SOAH DOCKET NO. 473-19-1265 2019 JAN 10 PM 12:55
PUC DOCKET NO. 48785

APPLICATION OF ONCOR	§	
ELECTRIC DELIVERY CO, AEP	§	
TEXAS INC. AND LCRA	§	
TRANSMISSION SERVICES	§	BEFORE THE STATE OFFICE
CORPORATION TO AMEND	§	
THEIR CERTIFICATES OF	§	OF
CONVENIENCE AND	§	
NECESSITY FOR 345-KV	§	
TRANSMISSION LINES IN	§	ADMINISTRATIVE HEARINGS
PECOS, REEVES, AND WARD	§	
COUNTIES, TEXAS	§

DIRECT TESTIMONY OF TERRY BURKES

COG OPERATING LLC

Figure 3- Route 320 with Concho's recommended modification to Link J7. See Attachment TB-3 for a larger version of this map.

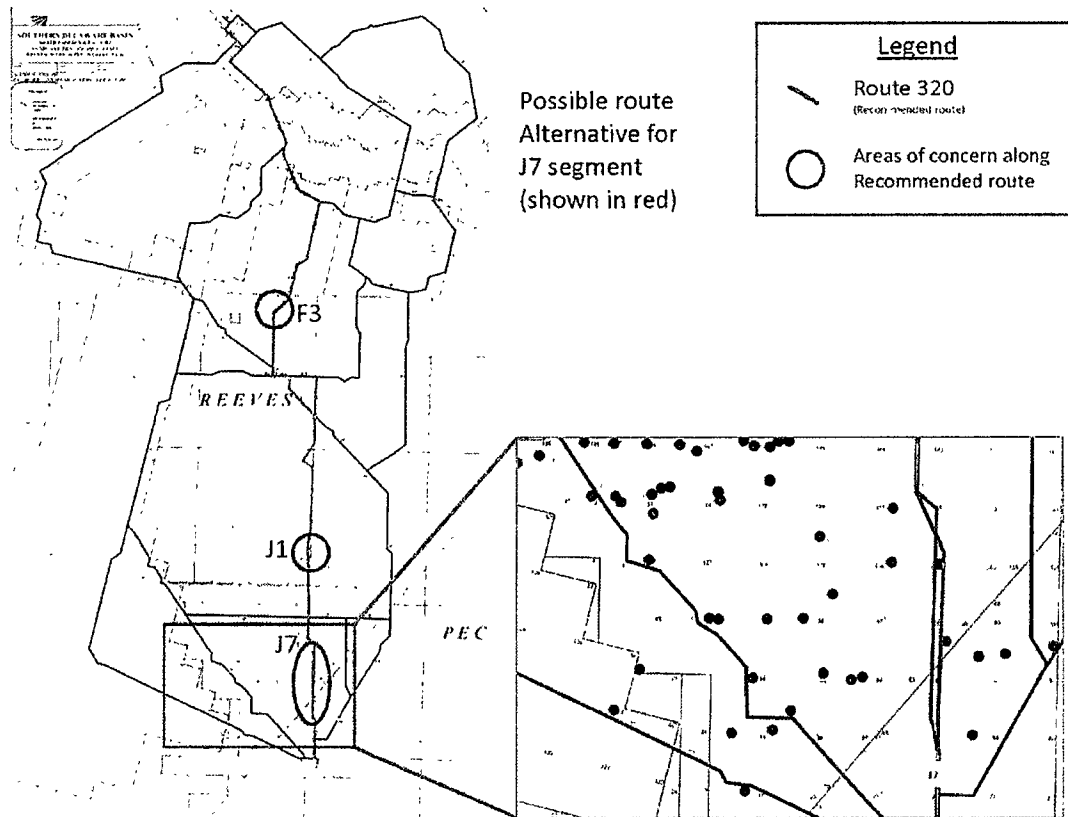
A. Figure 3 below (and *Attachment TB-3*) illustrate the recommended route, Route 320, in green. I inserted red circles on Links J7, F3, and J1 to identify Concho's concerns along Route 320. In each area I circled, the transmission line crosses Concho's existing oil and gas development and passes close to Concho's wells.

- 2 **Q. Please describe Link J7 and explain Concho's proposed modifications to that Link.**
- 3 A. Link J7 may affect Concho's Paradox offset locations, so I suggest a slight reroute pushing
- 4 the transmission line east. Instead of angling northwest in Section 58, Concho proposes
- 5 continuing due north to avoid Concho's well locations. Once the line enters Section 139,
- 6 then angle northwest to the originally-proposed J7 link. Concho's recommended angle
- 7 begins sooner than the utilities' proposed link and has a less severe angle than the
- 8 utilities' proposed link. The angle at the northern end of J7 also would be a less severe

angle than the utilities propose. The modification is included in the insert in Figure 3 above and *Attachment TB-3* to this testimony.

Figure 4- Route 320 with Concho's recommended modification to Link F3. See Attachment TB-4 for a larger version of this map.

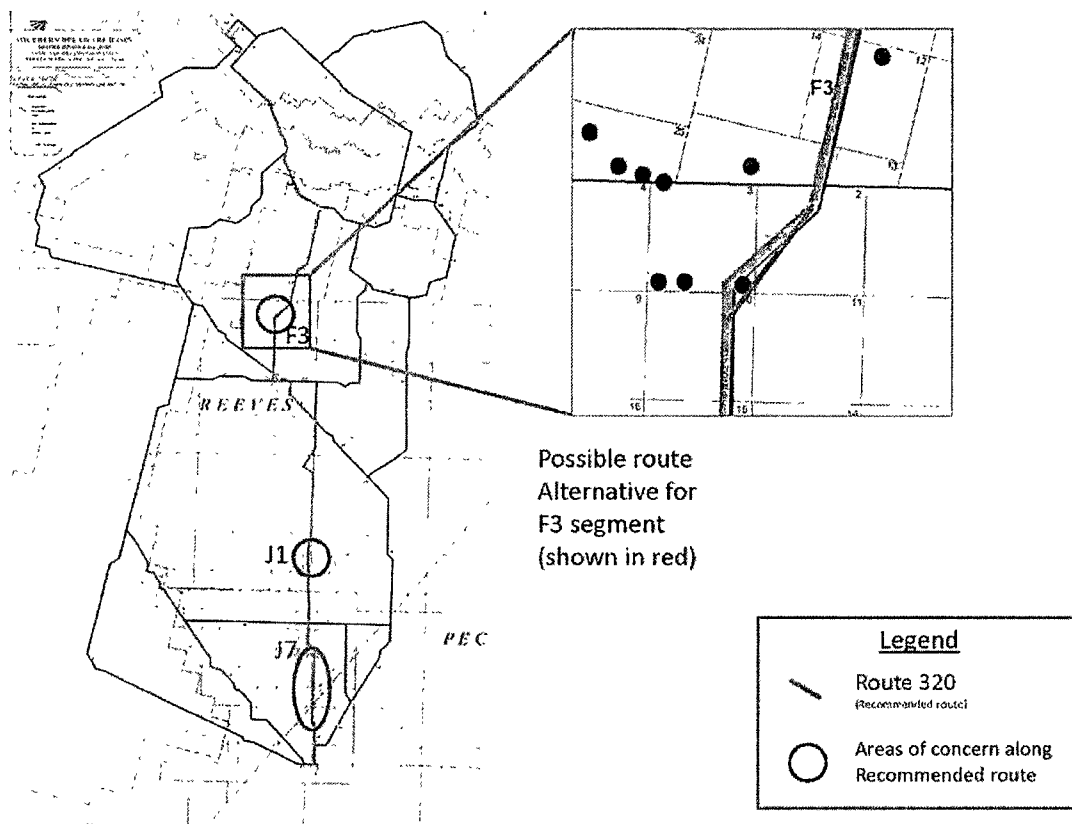
A. As proposed, Link F3 will cross near an existing Angler field well and compromise future project locations. Rerouting the transmission line a little further east will avoid the existing facility and minimize the effect on the future development in that field. My proposed modification softens two angles the utilities' propose. The modification is included in the insert in Figure 4 below and *Attachment TB-4* to this testimony.

Figure 5 - Route 320 with Concho's area of future concern on Link J1. See Attachment TB-5 for a larger version of this map

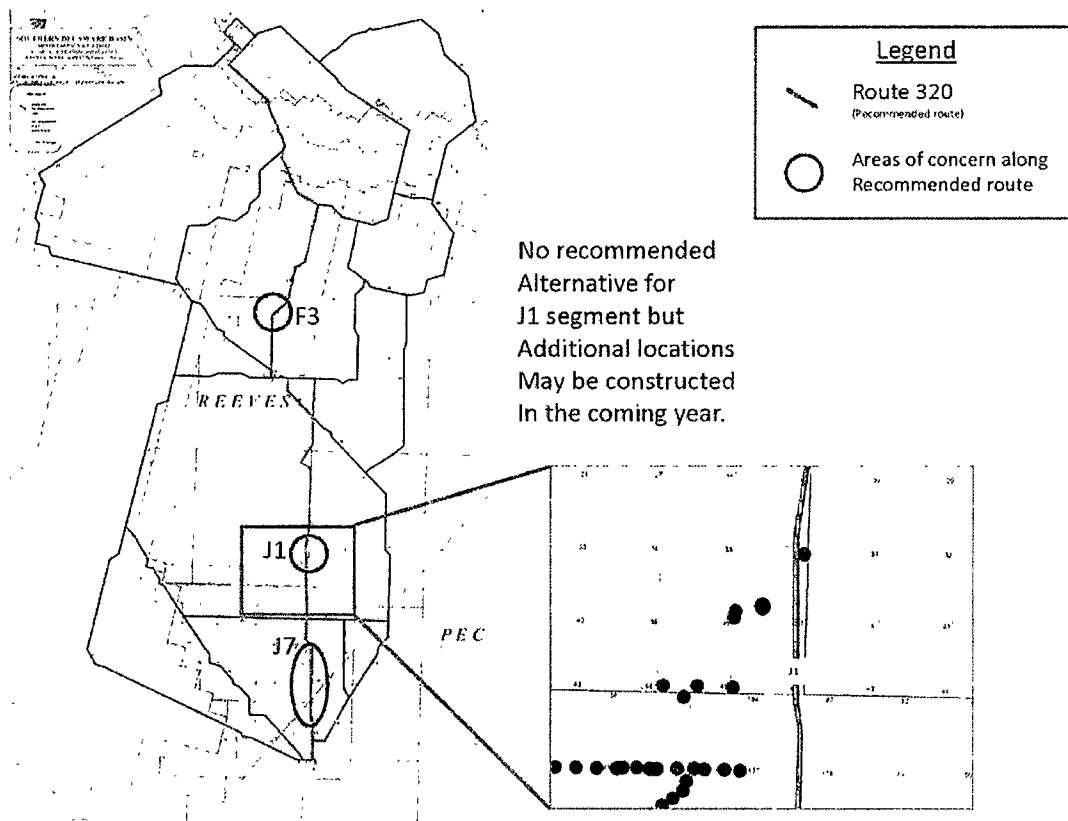
A. Link J1 does not affect existing facilities, but it is likely Concho—this year - will construct additional locations in the area I circled on the map. Figure 5 below and *Attachment TB-5* identify that area of concern.

Figure 6- Link D31 with Concho's recommended modification. See Attachment TB-6 for a larger version of this map.

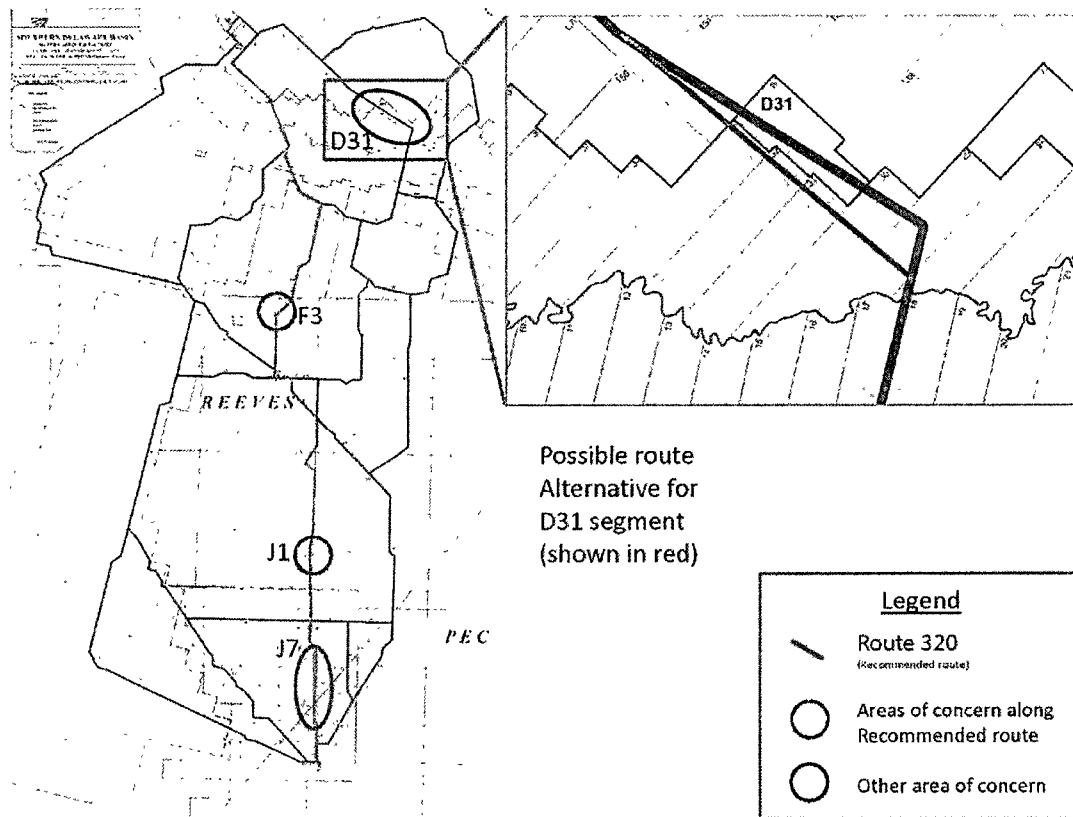
Q. What are Concho's concerns with Link D31 in the northeastern part of the study area?

A. I am not aware of any party proposing to use Link D31, but that link goes too far north before turning west, which requires a sharper turn to go west and another angle as the link

1 enters Section 155. You can see in Figure 6 below (and *Attachment TB-6*) that (if the
2 Commission requires the utilities construct the project on Link D31) the Concho-
3 proposed revision softens the angle turning west and makes the connection in Section 155
4 a tangent connection instead of a soft angle. From Concho's perspective, moving the
5 transmission line further southwest from the top of Section 157 will place greater distance
6 between Concho's wells and the transmission line.
7

Attachment TB-3
Recommended Route 320 and Concho's areas of concern
and Concho's proposed modification to Route 320, Link J7

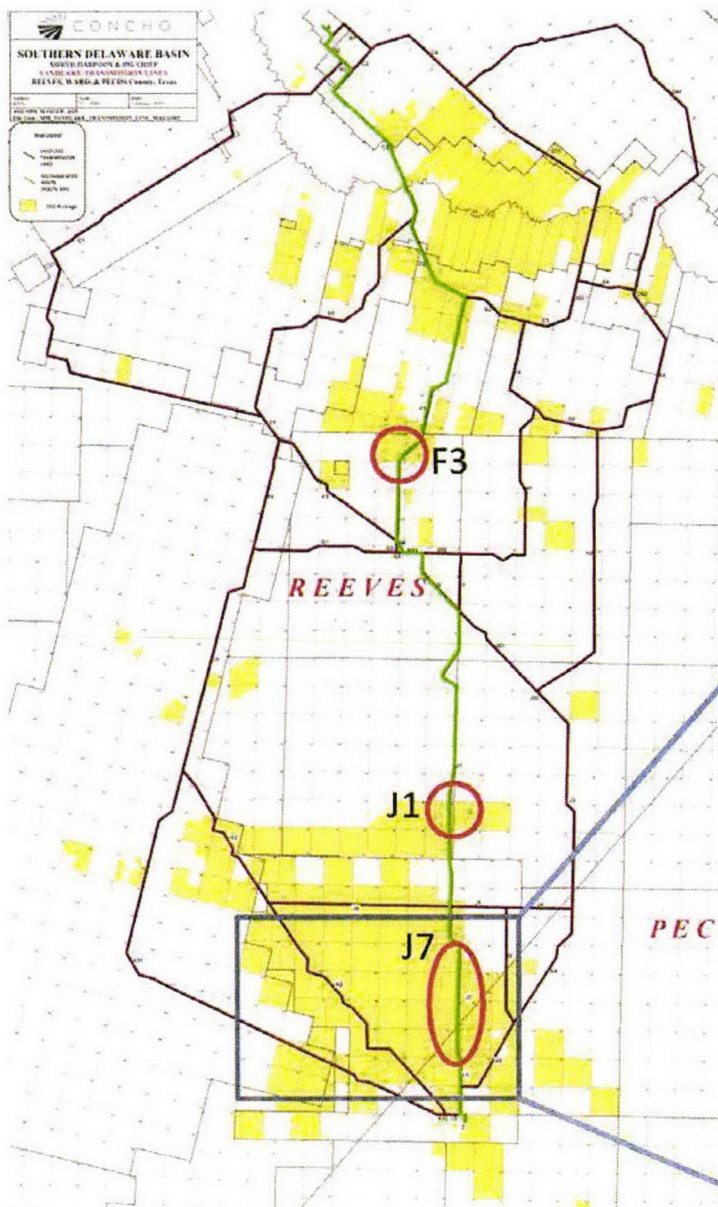
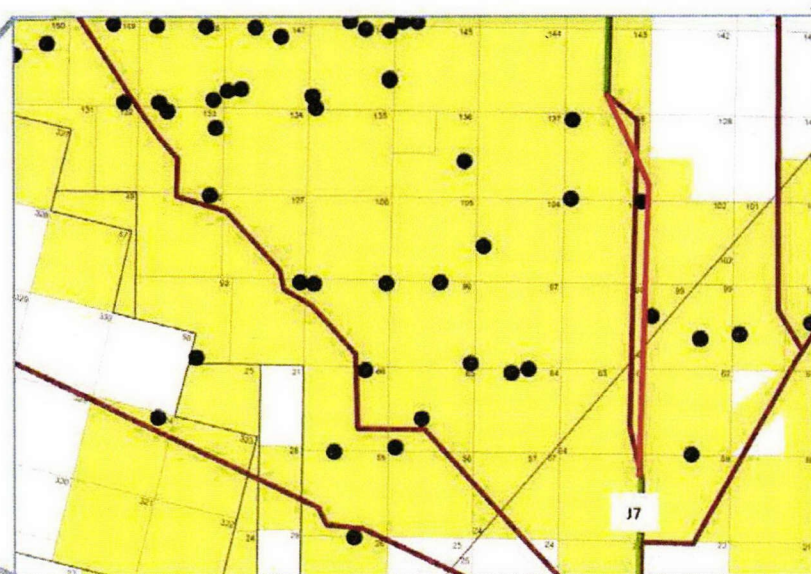
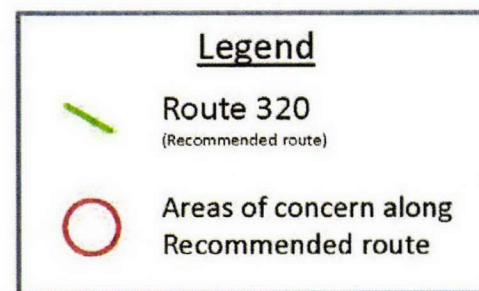
Possible route
Alternative for
J7 segment
(shown in red)

Attachment TB-4
Concho's proposed modification to Route 320, Link F-3

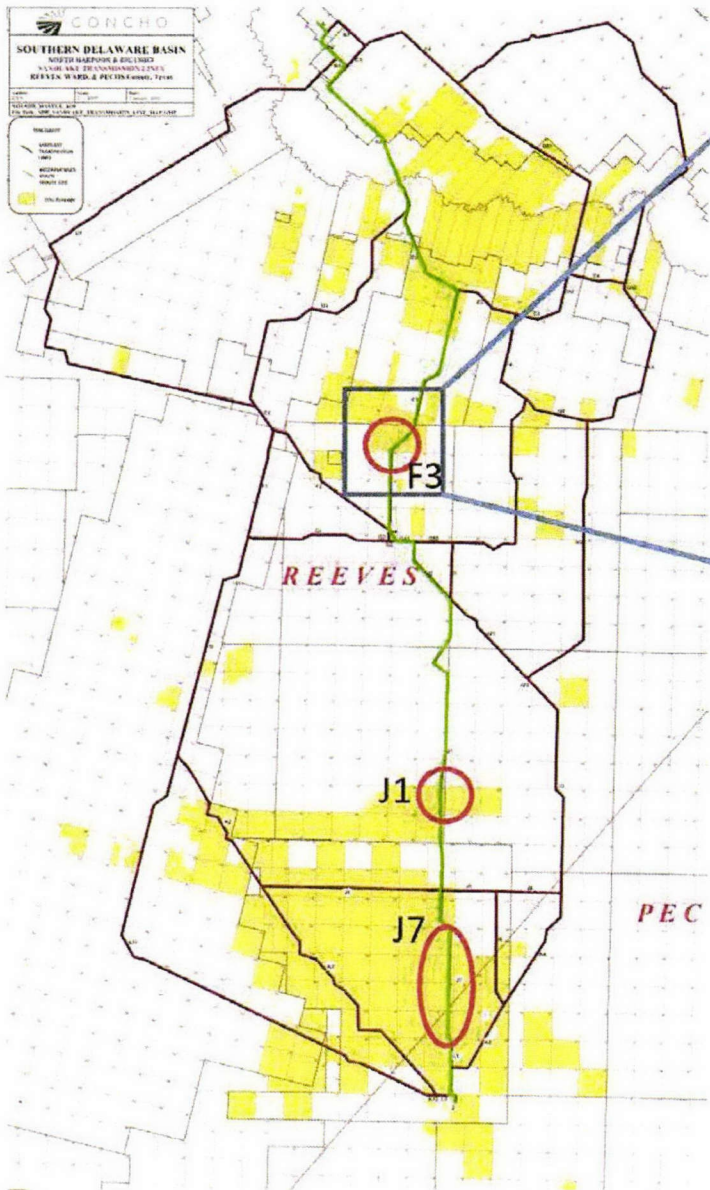
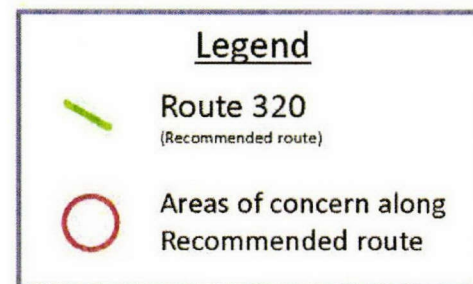
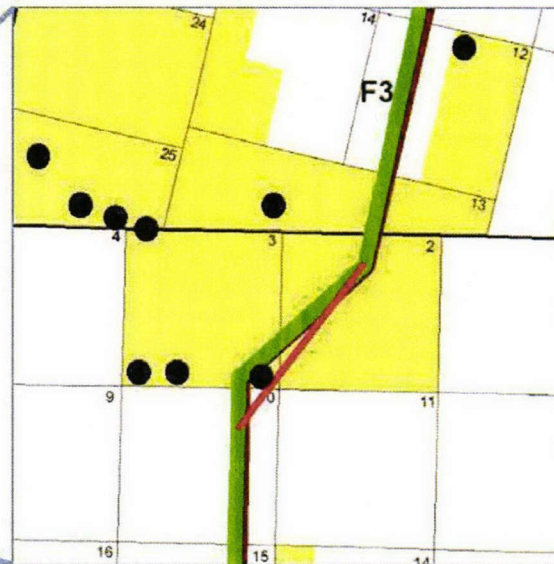
Possible route
Alternative for
F3 segment
(shown in red)

Concho's identification of future development on Route 320, Link J1

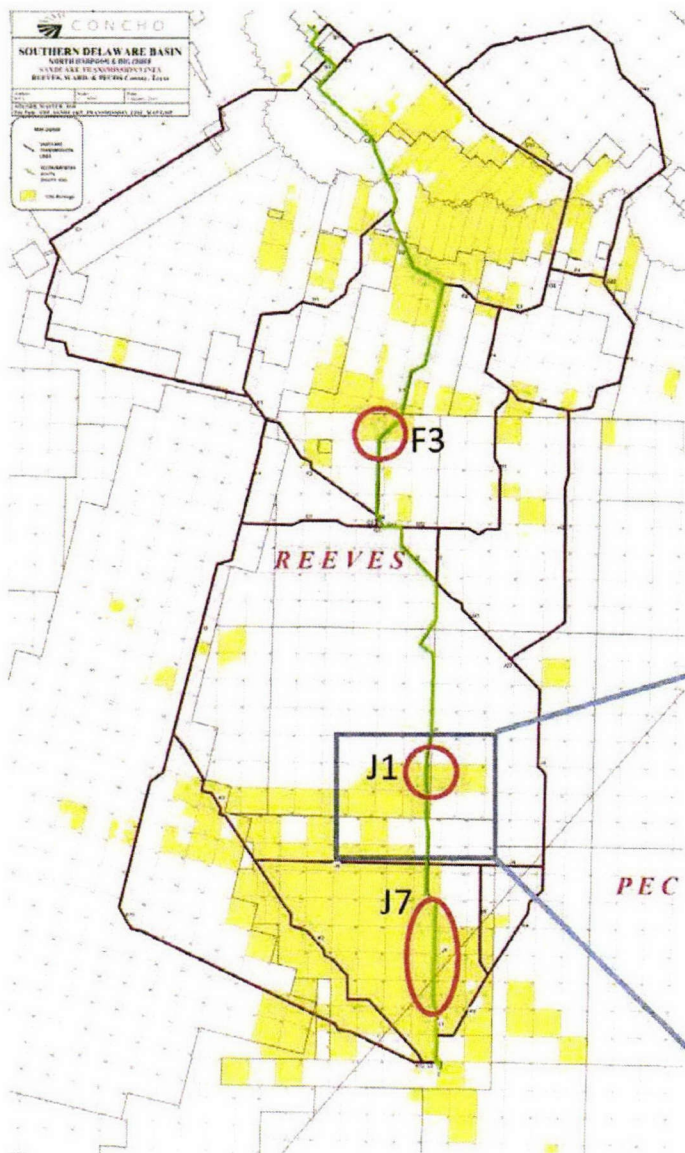
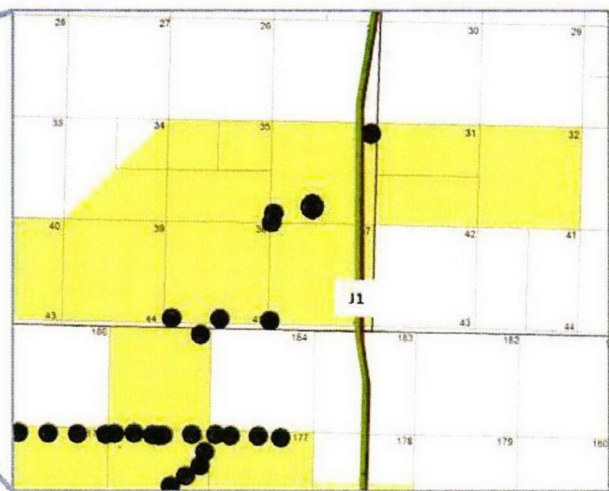
No recommended
Alternative for
J1 segment but
Additional locations
May be constructed
In the coming year.

Attachment TB-6
Concho's proposed modification on Link D31

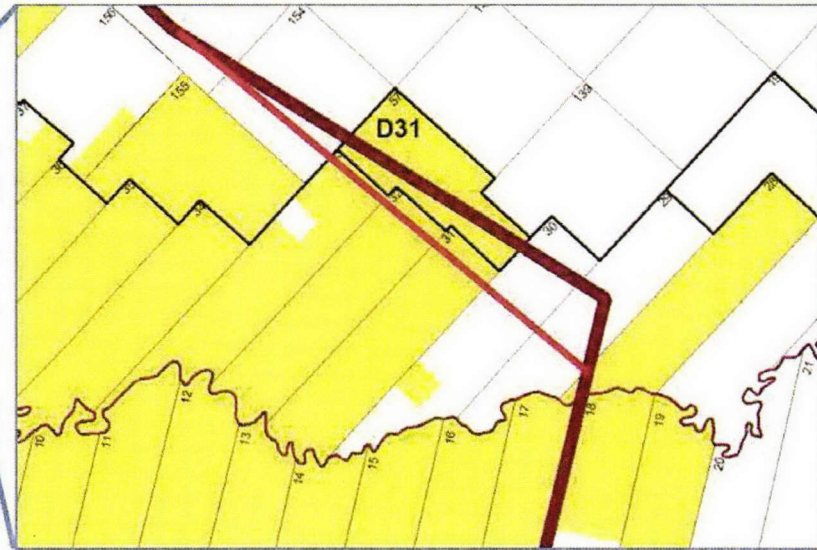
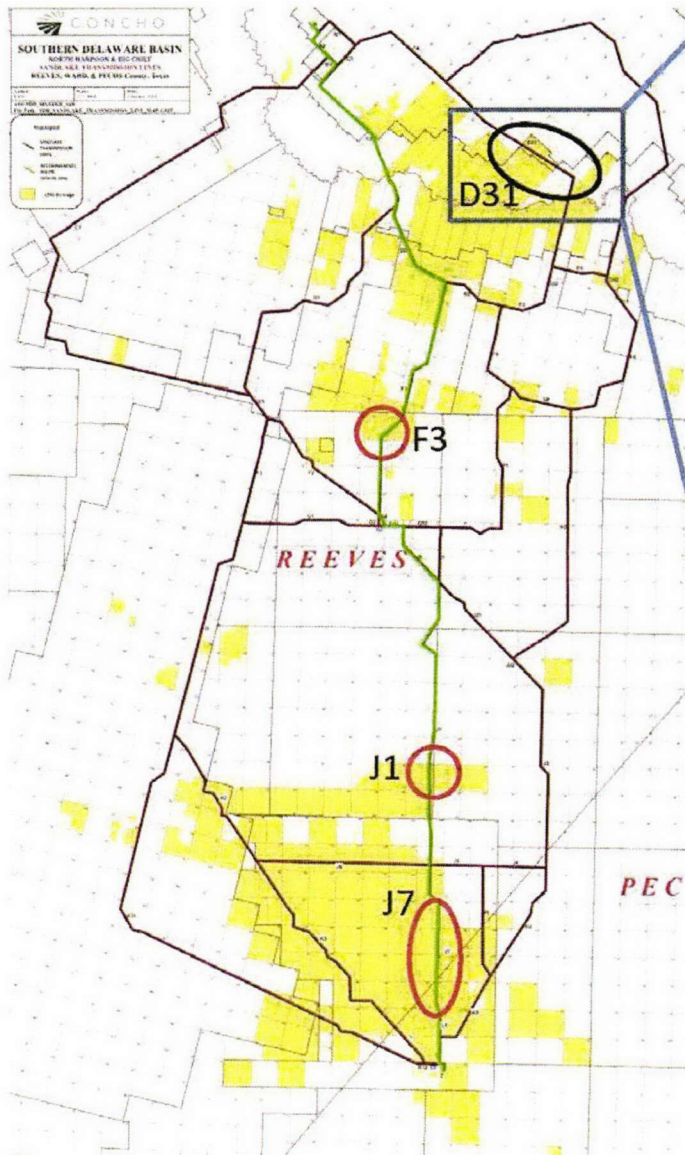
Possible route
Alternative for
D31 segment
(shown in red)
